City of Miami Beach
Last Completed Item Reviews Across All Submittals

Permit Type: Building - Commercial **Work Class:** Alteration (w/o Phased) **Application Date:** 05/22/2020 **Status:** Approved
Address: 235 WASHINGTON AVE **Permit:** BC2013662

Re: Response to City Comments.

Sobe Hostel
235 Washington Ave.
Miami Beach, Florida

Date	JUNE. 08, 2020	Sheet No.
Scale	AS INDICATED	A3.00
Project	1967

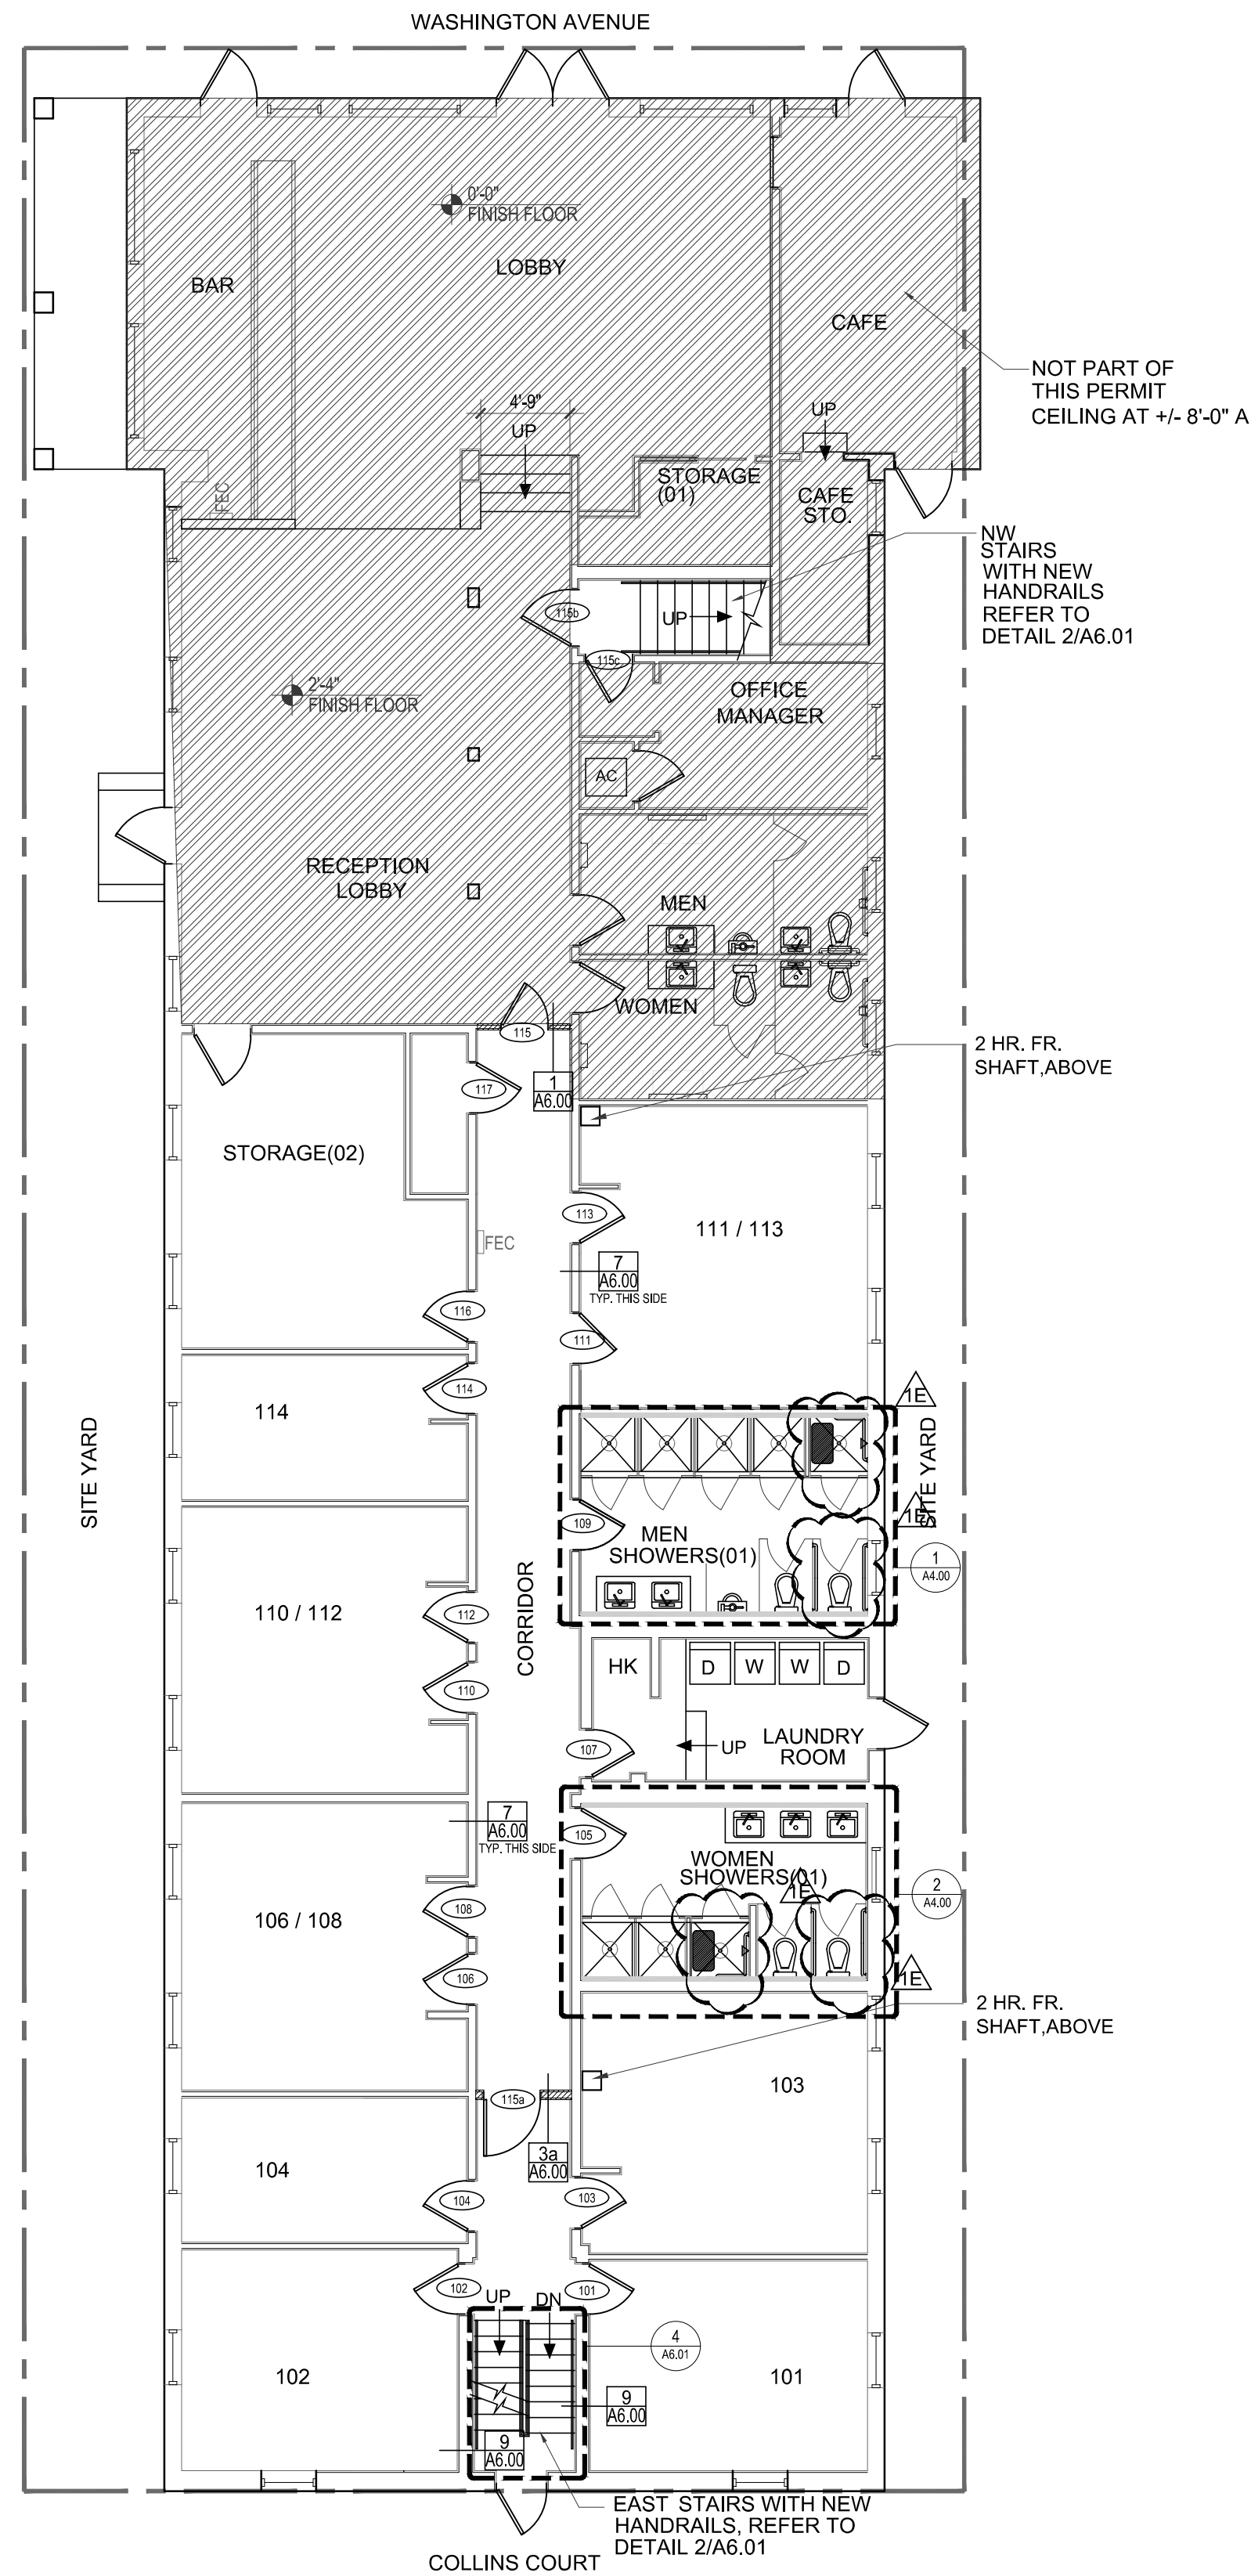
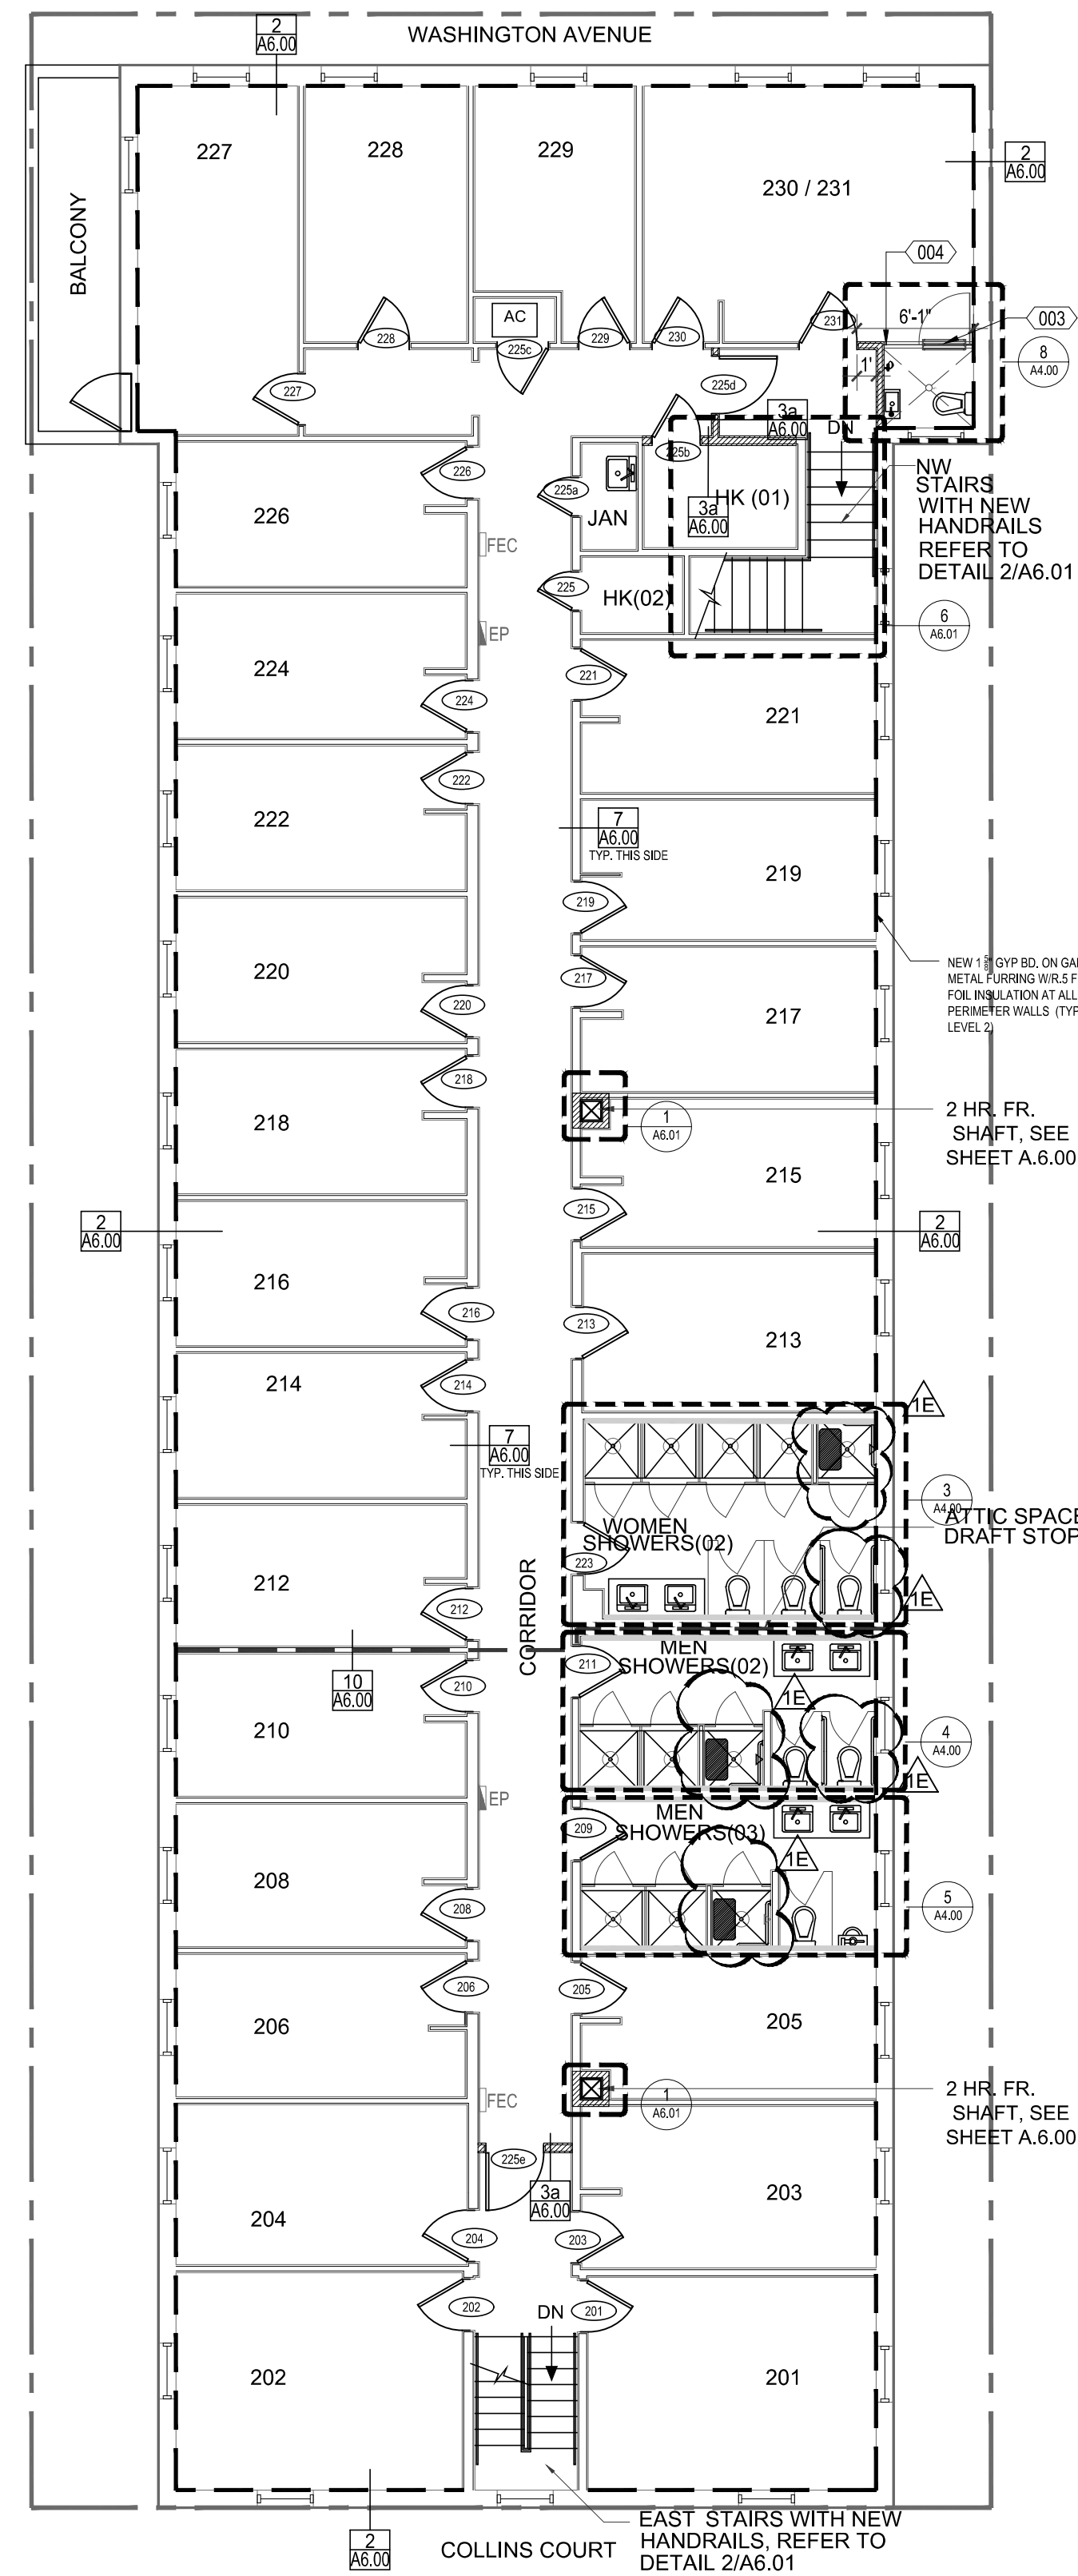
2. Tag all walls/partitions to verify compliance with the ffpc 6th ed 6.1.14.4.1(a)(b) typical for all floors

3. Plans shows a manager's office that opens into the exit enclosure that does not comply with the ffpc 6th ed 7.2.2.5.3

4. Plans show the first floor with an area that is hatched, clarify if out of scope of work

KKAID Response: New partitions are tagged on this sheet with reference to details on sheet A6.00

KKAID Response: Room condition are existing to remain and not part of this permit for renovation

KKAID Response: Cross hatched areas are existing and not part of this renovation

Date	JUNE. 08, 2020	Sheet No. A3.01
Scale	AS INDICATED	
Project	1967

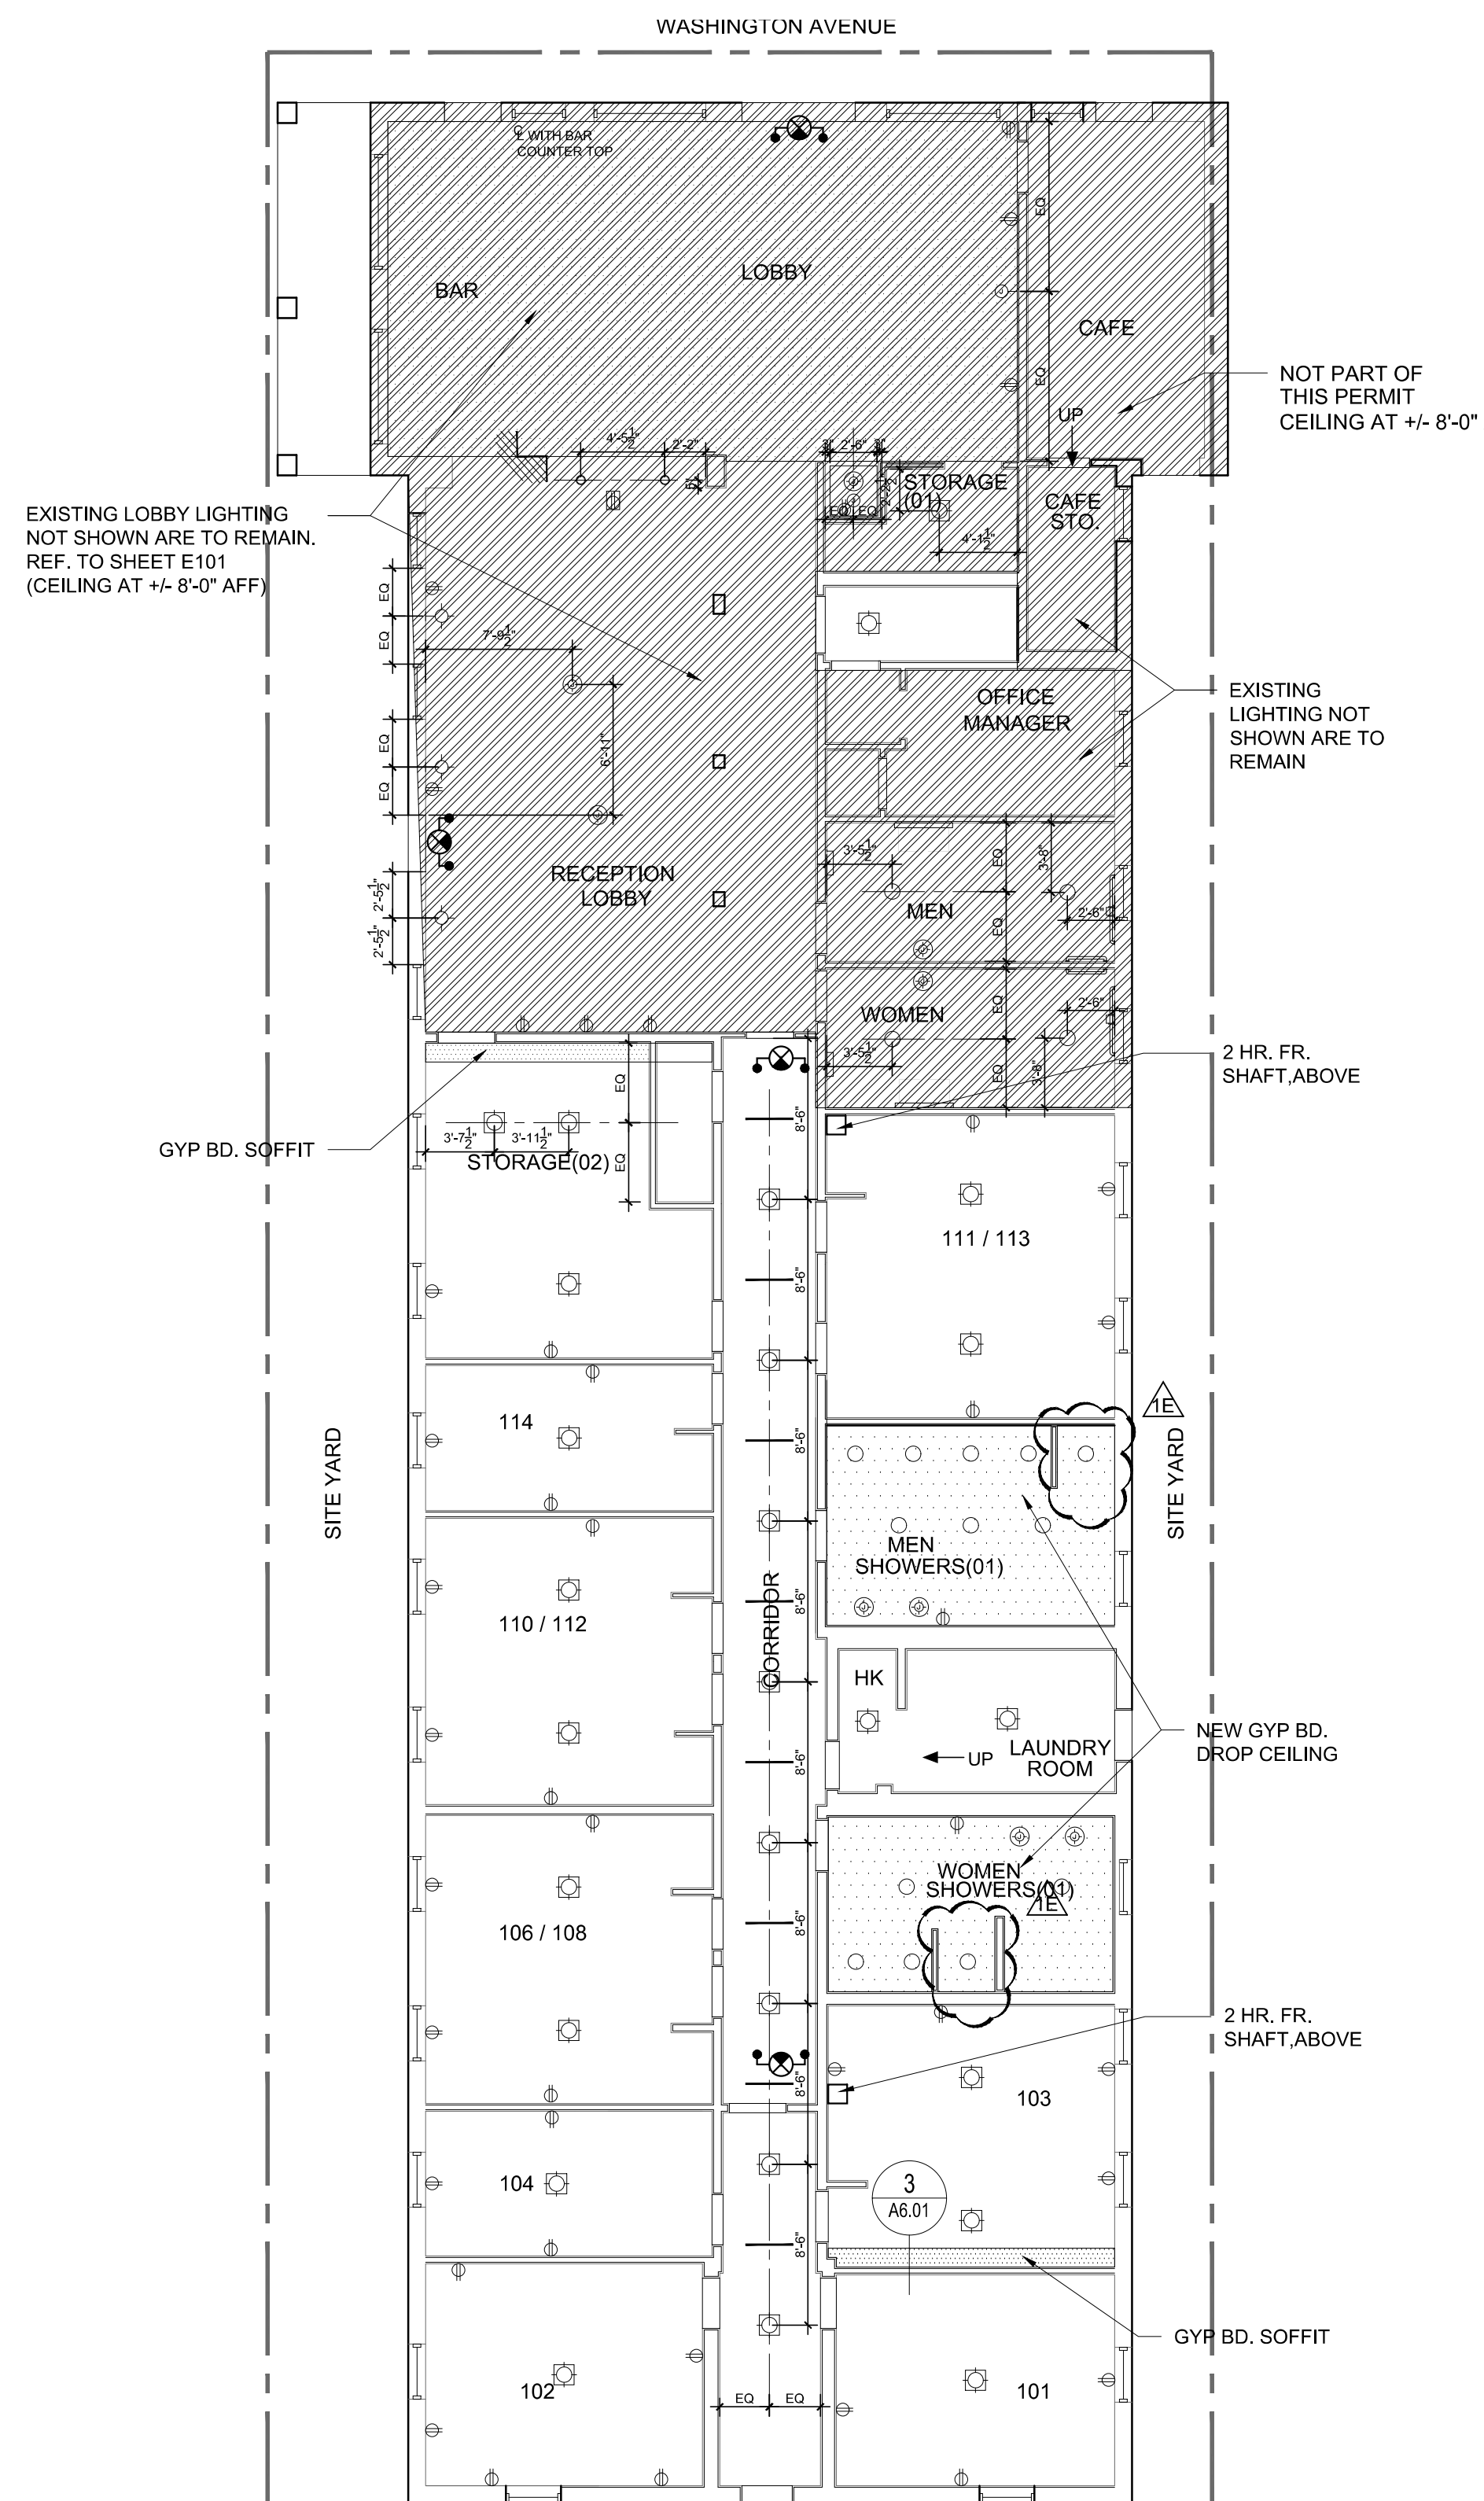
1. Provide ceiling height throughout (including hatched area) to verify compliance with the ffpc 6th ed 7.1.5 headroom

KKAID Response: Refer to ceiling legend for existing and proposed ceiling heights, clouded as #1A. Cross hatched area ceilings are existing to remain at height as shown
